# SAFETY ALERT

## Securing of control system bolts

**SA-SECS-CT\_\_-01;**  
**SA-SECS-CT2k-01;**

Technical Advise 6.1 E

CT

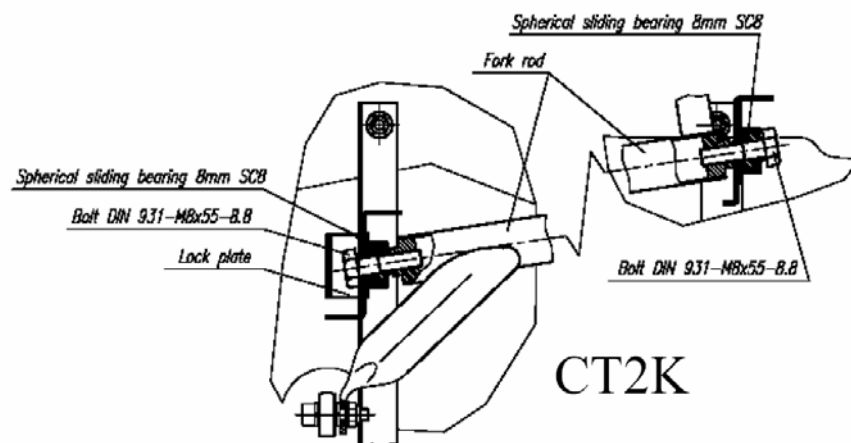
1. Because of corrosion at the CT built 1997 a torsion bearing was sized. Out of this reason the pin in the bearing was loosened and screwed out. First CT2K was built in 2000. Additional lock plates are stipulated.

- It has to be insured that the lubrication of bearing and hinges according the flight & maintenance manual is made accordingly.
- The bearing pins and the flap connecting bolt have to be checked if fixed. If loose, they have to be tightened and secured with loctite (hard) or a safety pin.
- The cables for airbox & heating have to be cut to minimal length

Connection of Rod Rocker

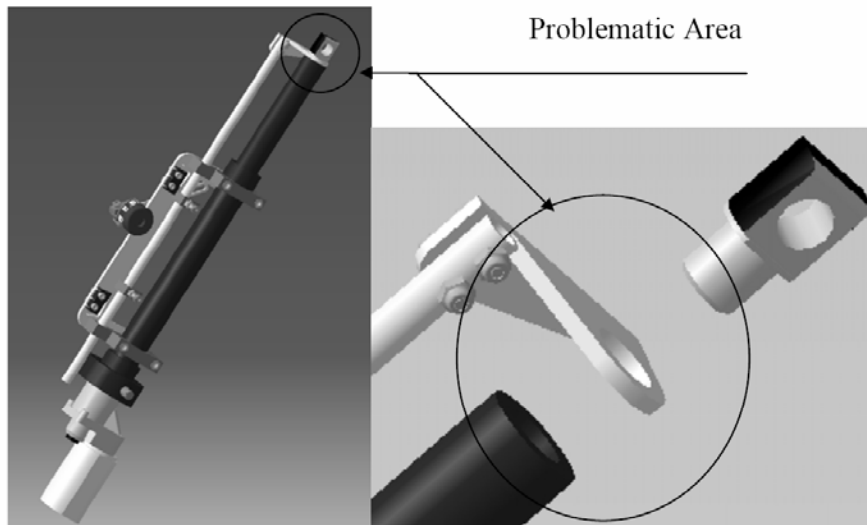
- The CT2K built 2003 the connecting bolt between the none rotating tube at the flap engine and the flaps was screwed out. It was visibly that the bolt was secured with loctite, in trials, even with none secured bolts, this could not be reached.

For fixing of tip a bolt A2 913 4x6 could be used

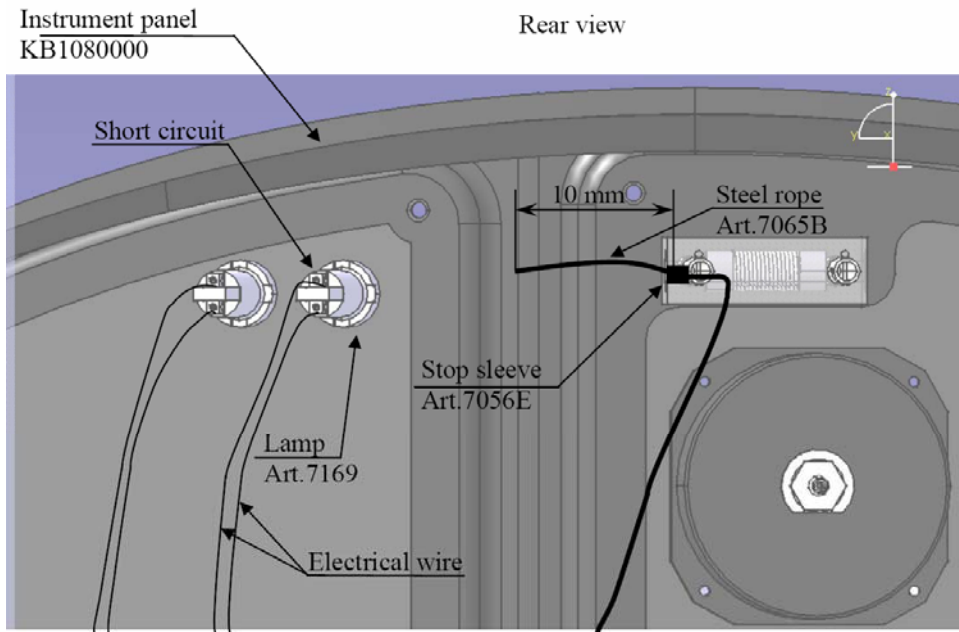
- The CT2K built in 2002 a shortcut was noted during flight. Reason was that the extended cable of the airbox lever has shortcut the warning lamps. To avoid the shortcuts, the free end of the cable must not exceed 10mm. This point has been included into the final check list.
